# PREVOST

## WARRANTY BULLETIN

**WB24-24**

DATE :	August 2024	SECTION:	06 ELECTRICAL
EXPIRATION:	August 2026		
SUBJECT:	<b>CB5 BREAKER REPLACEMENT</b>

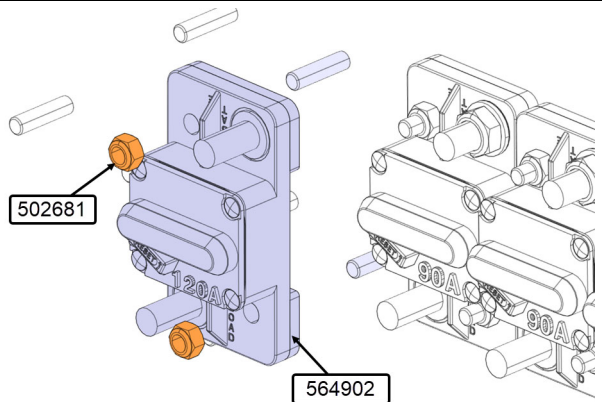
16. Install the new breaker CB5 564902 with the new nuts 502681 (2x).

17. Tighten the nuts to **7 lb-ft** torque.

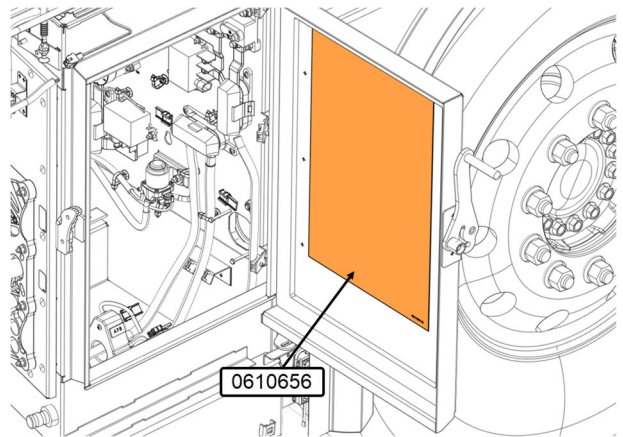
32. Install the new decal of the rear junction box components 0610656.

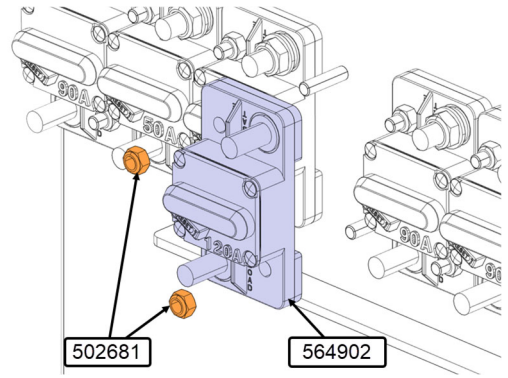
18. Install the new breaker CB5 564902 with the new nuts 502681 (2x).

19. Tighten the nuts to **7 lb-ft** torque.

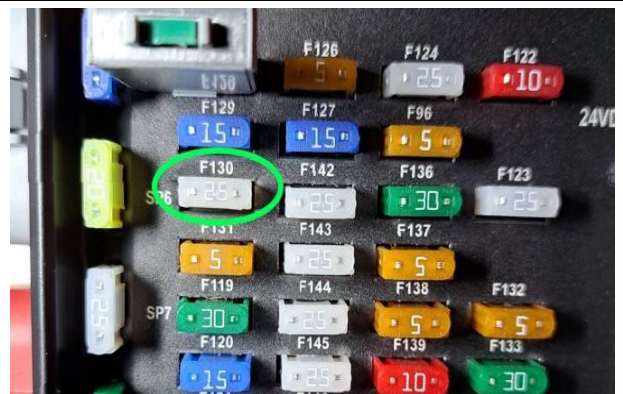
38. Replace the fuse **F130** with the new 563153.

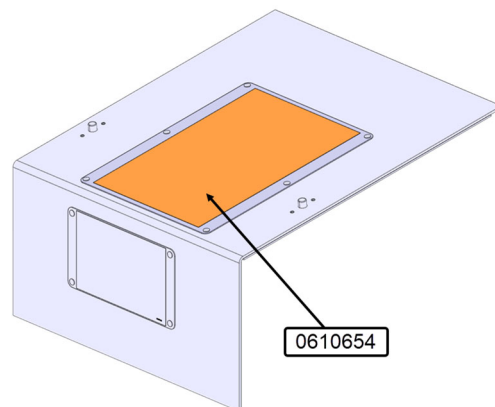
50. Install the new decal of the rear junction box components 0610654.
